**Amendments to the Drawings:**

Appl. No. 09/977,734  
Amdt. Dated Feb. 25, 2004  
Reply to Office Action of Jan. 15, 2004  
Replacement Sheet

Fig. 1

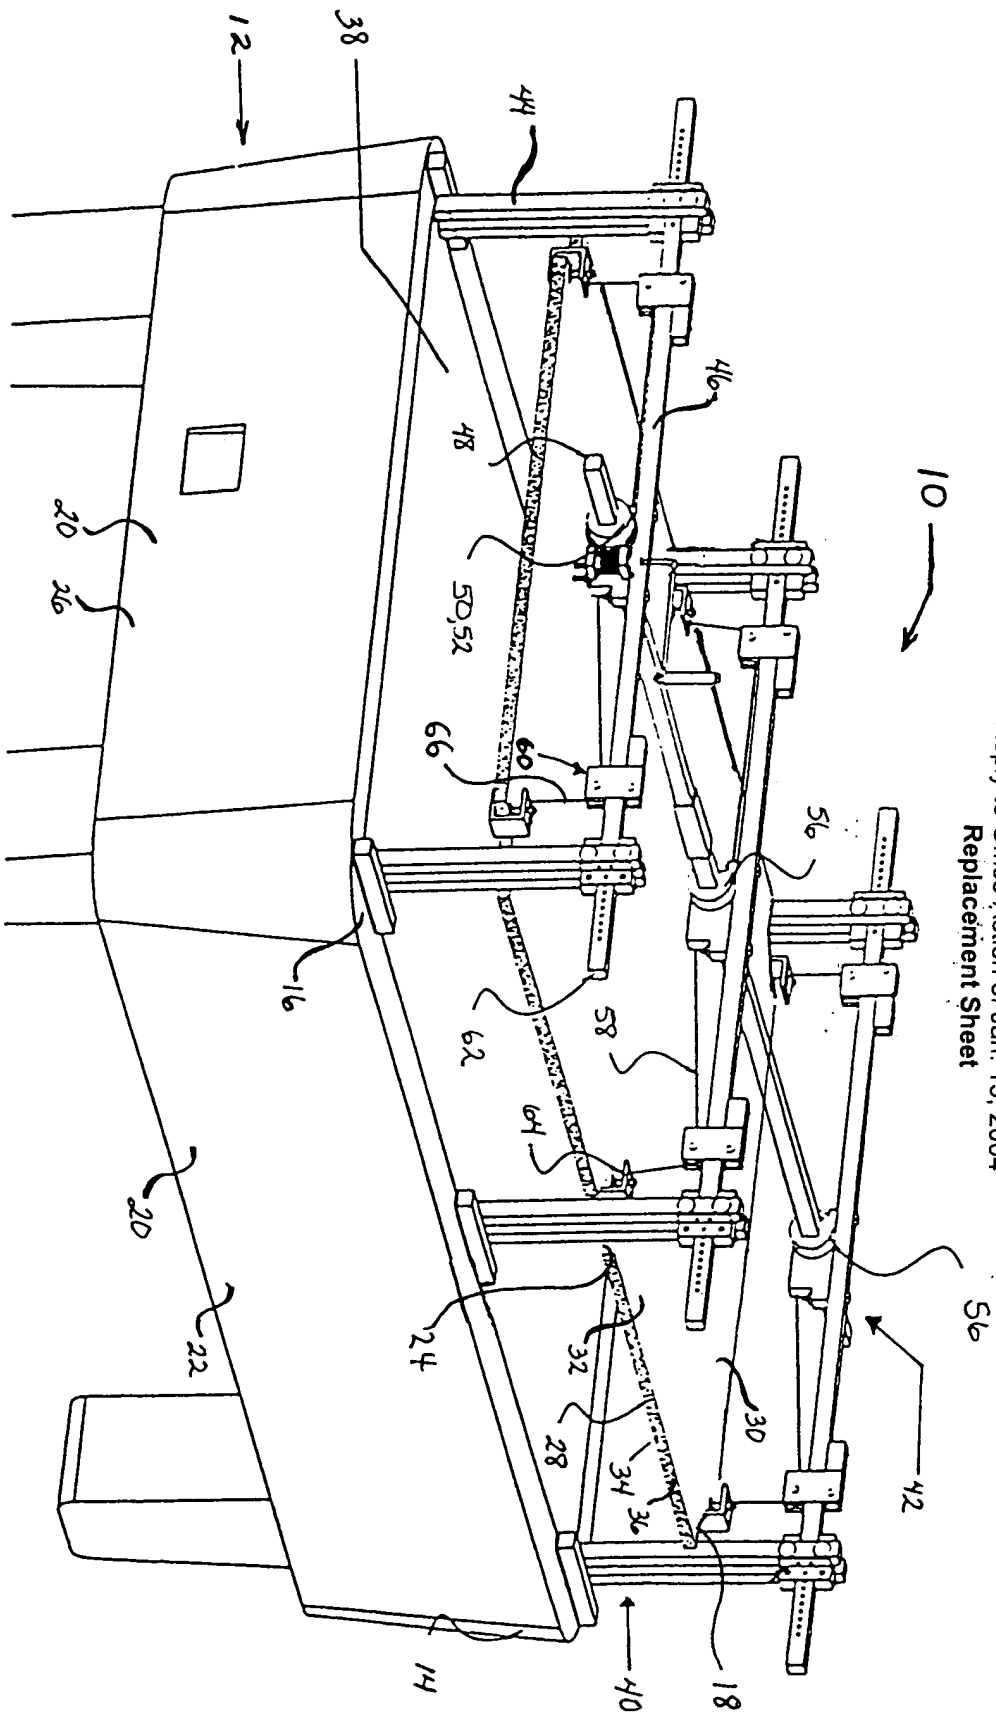
The attached sheets of drawings include changes to Figs. 1-4. The sheets containing Figs. 1-4 replace the original sheets that included Figs. 1-4. In Fig. 1, references to cable protruding end 66 and pockets 18 and 24 have been added. In Fig. 2, reference to element side support bracket brace 78 has been added, and the number identifying adjustment hole 76 has been corrected by replacing the incorrect number, 86. In Fig. 3, references to cable protruding end 66 and crank 82 have been added, and reference 78 has been deleted. In Fig. 4, reference to element 32 has been deleted.
